NEW MEXICO OIL CONSERVATION DIVISION
- Engineering Bureau -
1220 South St. Francis Drive, Santa Fe, NM 87505

APPLICATION FOR AUTHORIZATION TO INJECT

WELL NAME & NUMBER: Brininstool 25 Federal No. 1

Proposed Re-entry and SWD Completion Diagram

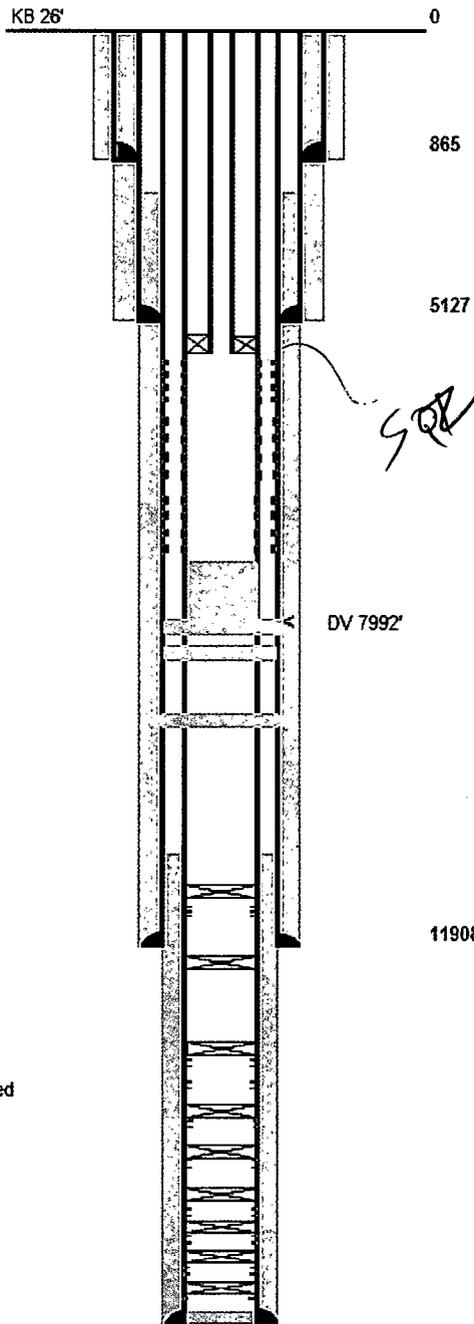
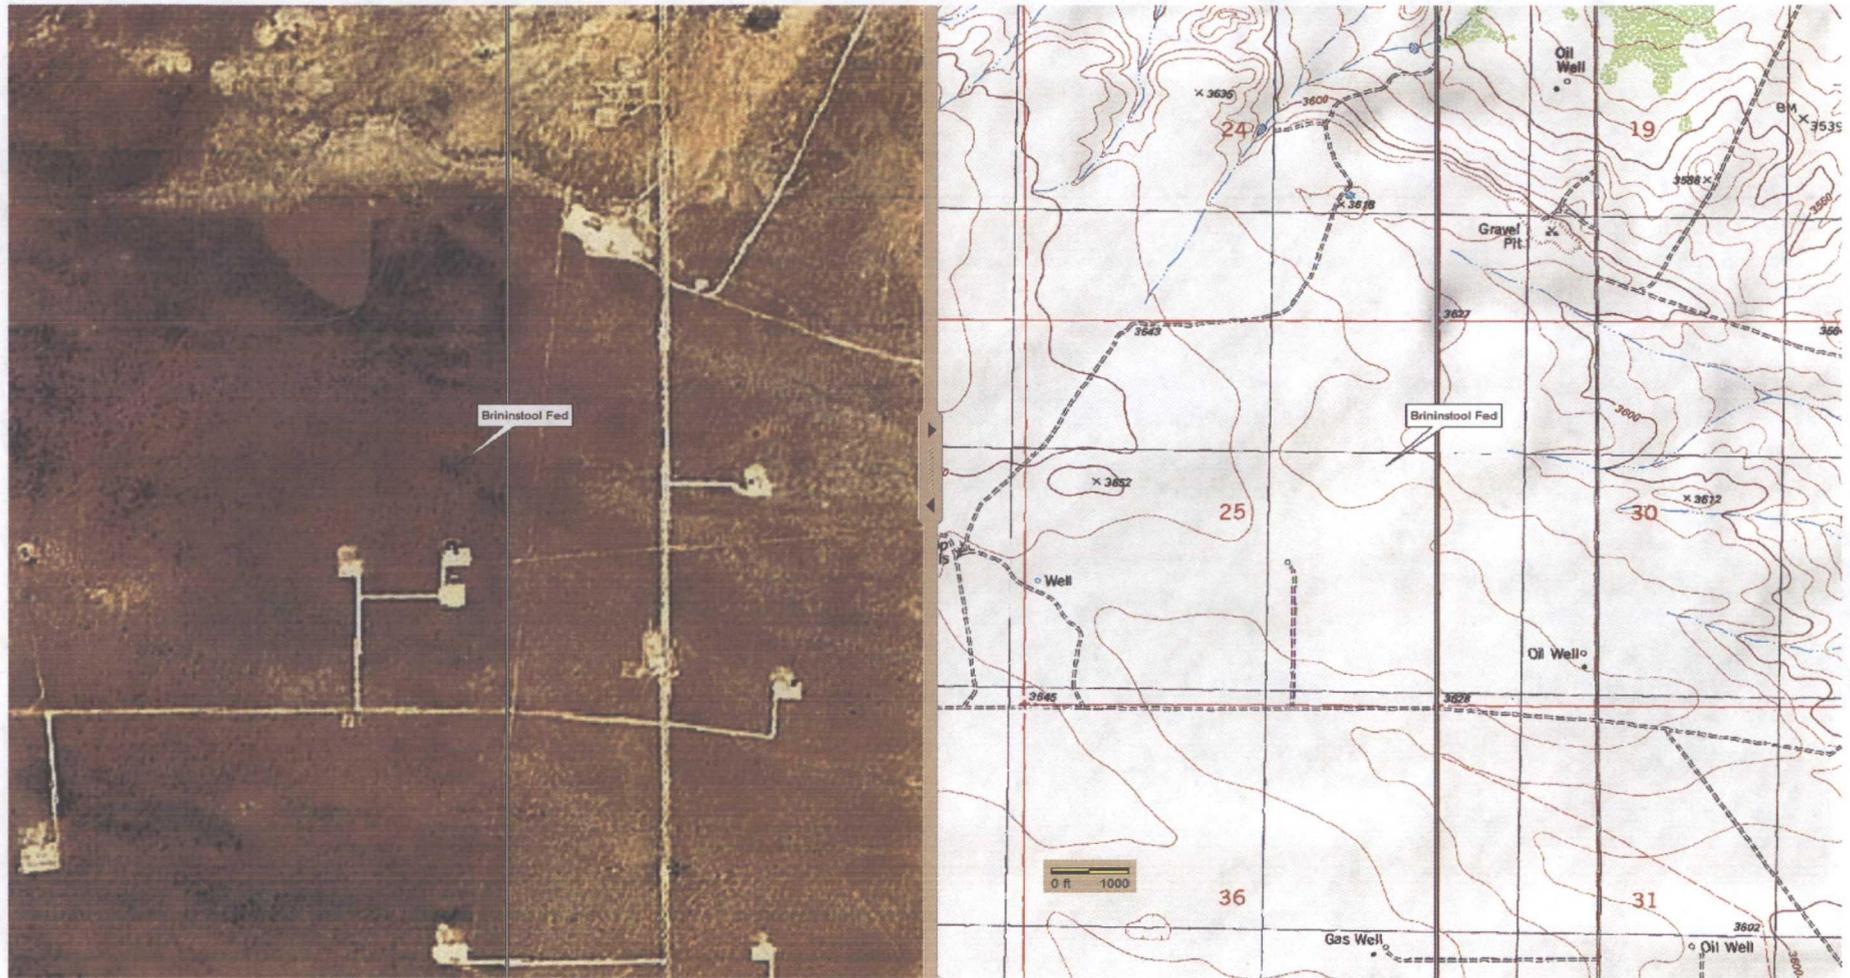
- ✓ (3) Do you plan to squeeze the 4-1/2 – 7 inch annulus over the top of your disposal interval or leave it open? Would you send a summary of the planned re-entry procedure that has this info on it?

- (3) Do you plan to squeeze the 4-1/2 – 7 inch annulus over the top of your disposal interval or leave it open? Would you send a summary of the planned re-entry procedure that has this info on it?

- (3) Do you plan to squeeze the 4-1/2 – 7 inch annulus over the top of your disposal interval or leave it open? Would you send a summary of the planned re-entry procedure that has this info on it?

✓ (3) 4-1/2" to 7" annulus opening above disposal interval - leave or squeeze? Will be squeezed. Re-entry plan attached as PDF.

API: 3002534782 ²⁵⁴⁷³
 Operator: C.W. Trainer
 Lease: Mary Federal
 Location: Sec 25, T23S-R33E Lea Co., NM
 Footage: 1980 FSL, 1980 FEL

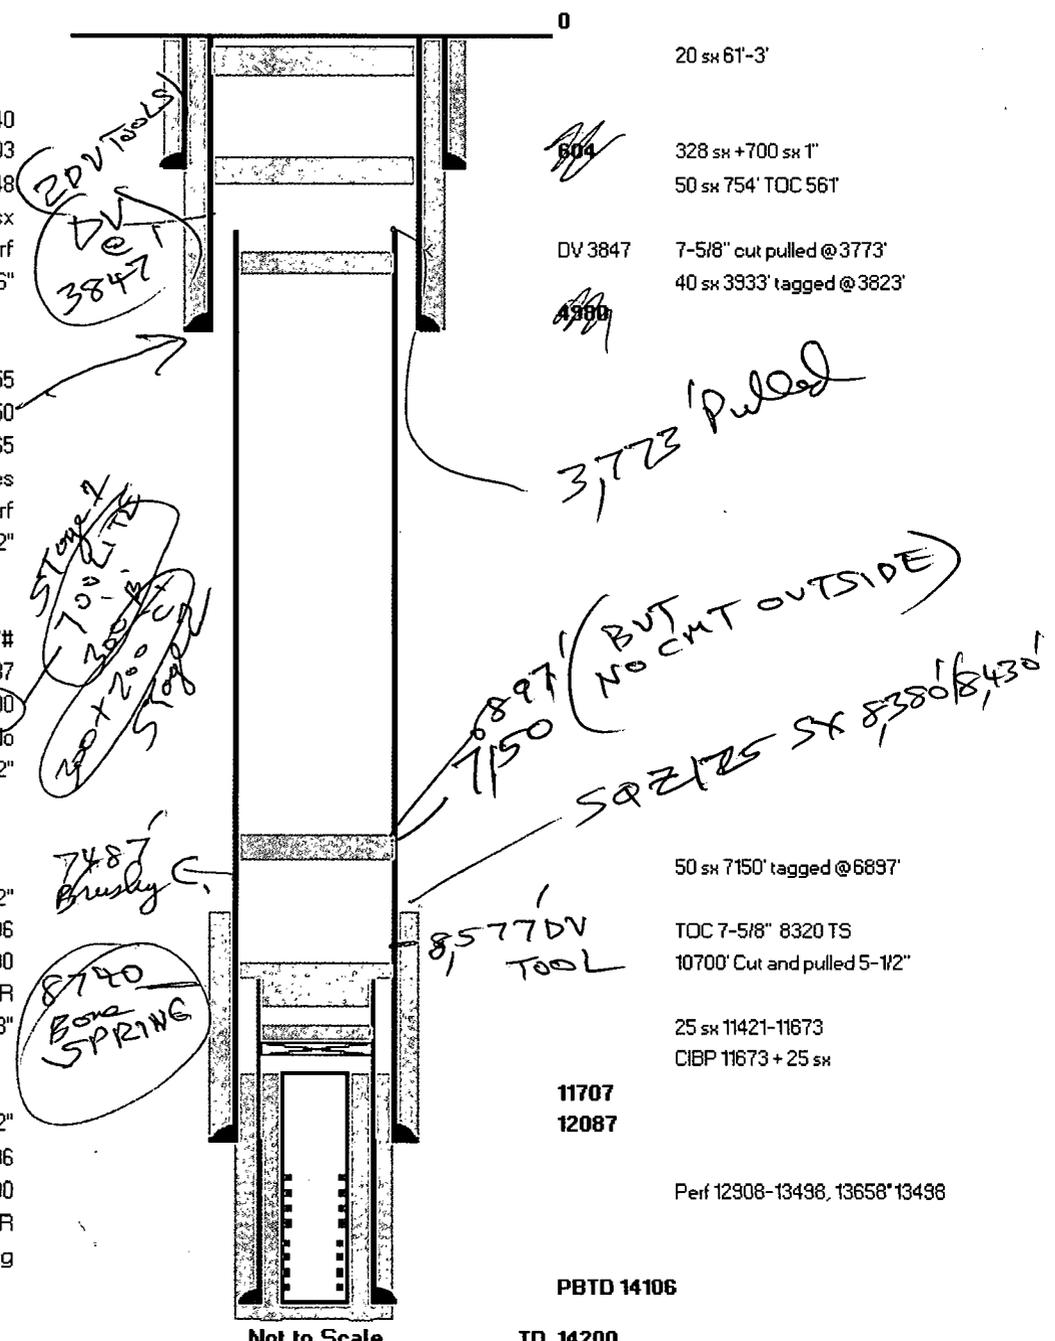
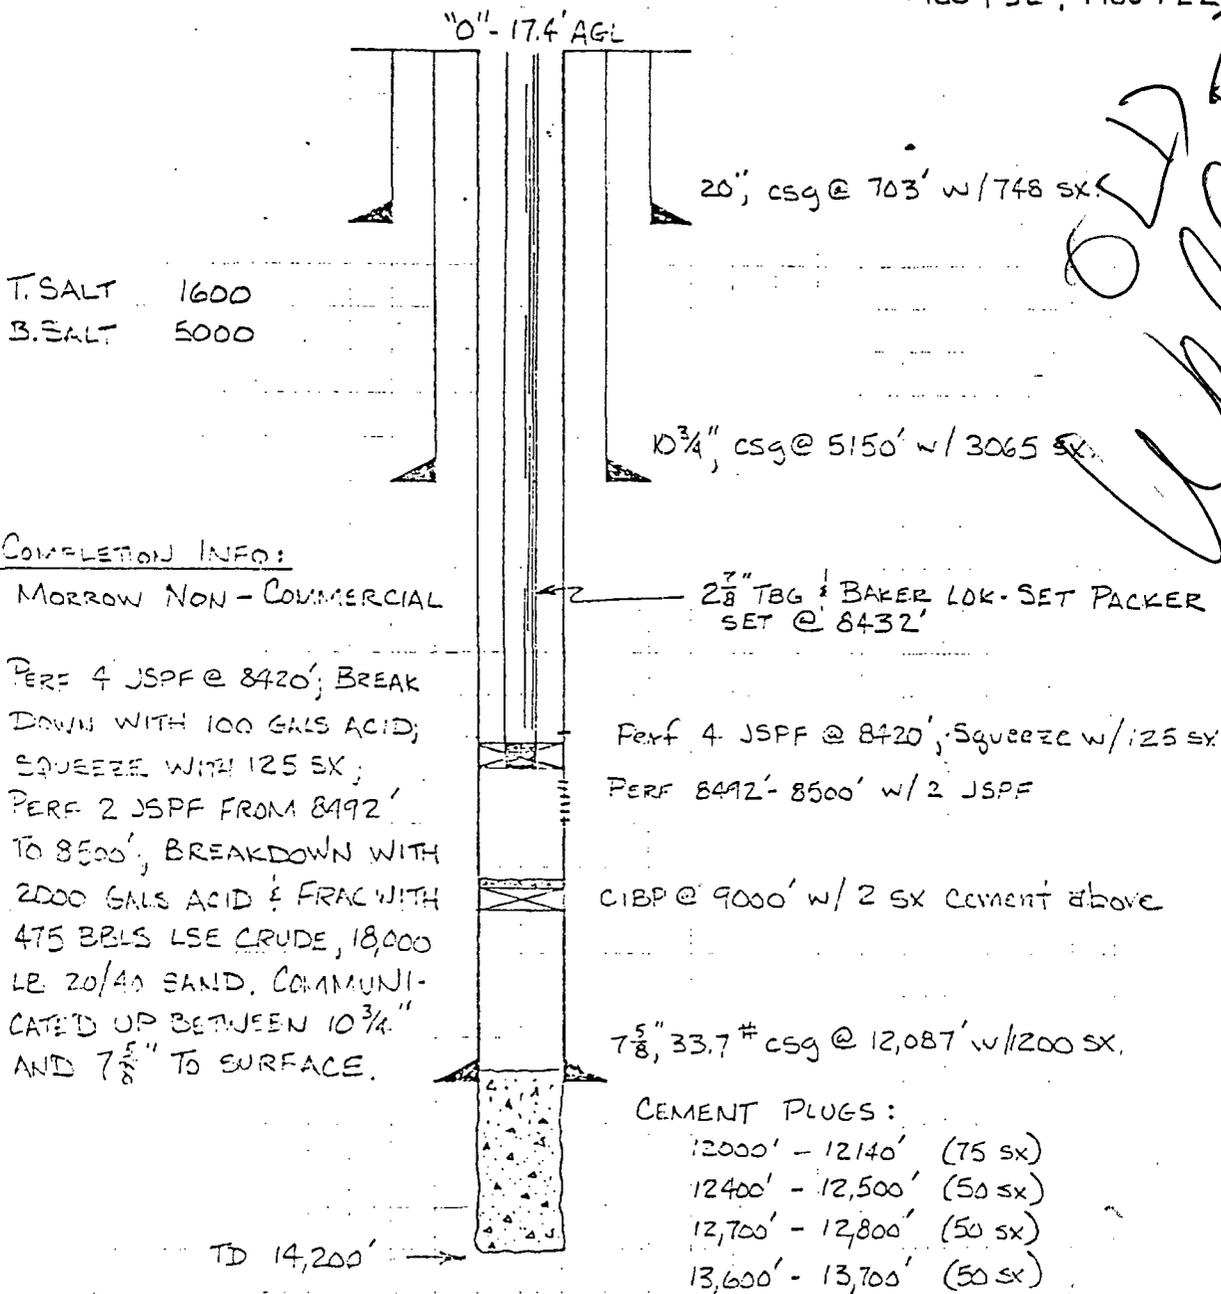
- (4) There is one well in the AOR that may not have isolation of your proposed disposal depth range – the file is a bit unclear but it seems the 30-025-25473 well has open 9-1/2 inch hole to 7-5/8 inch casing annulus across the entire Delaware section. The well may be relatively easy to re-enter and squeeze to isolate your interval. Alternatively, depending on the answer to (2) above, you could re-advertise this disposal well for the entire unbounded interval. Let me know what Delaware Water Company will agree to do.

- (4) There is one well in the AOR that may not have isolation of your proposed disposal depth range – the file is a bit unclear but it seems the 30-025-25473 well has open 9-1/2 inch hole to 7-5/8 inch casing annulus across the entire Delaware section. The well may be relatively easy to re-enter and squeeze to isolate your interval. Alternatively, depending on the answer to (2) above, you could re-advertise this disposal well for the entire unbounded interval. Let me know what Delaware Water Company will agree to do.

- (4) There is one well in the AOR that may not have isolation of your proposed disposal depth range – the file is a bit unclear but it seems the 30-025-25473 well has open 9-1/2 inch hole to 7-5/8 inch casing annulus across the entire Delaware section. The well may be relatively easy to re-enter and squeeze to isolate your interval. Alternatively, depending on the answer to (2) above, you could re-advertise this disposal well for the entire unbounded interval. Let me know what Delaware Water Company will agree to do.

The following were originally emailed 8/24/2012 - the unanswered item 4 was the question as to Delaware Water's willingness to re-plug the Trainer well. Re-plugging Trainer would be OK and preferable to re-submital..

Will, please just delete the message below. I found my stuff, and found my response was delayed by the protest. It was a period in August where my emails were not getting through to you. Delaware Water will re-plug the Trainer well. I will resend my responses to your 5 points of 8/16/2012. My apologies.
Kay
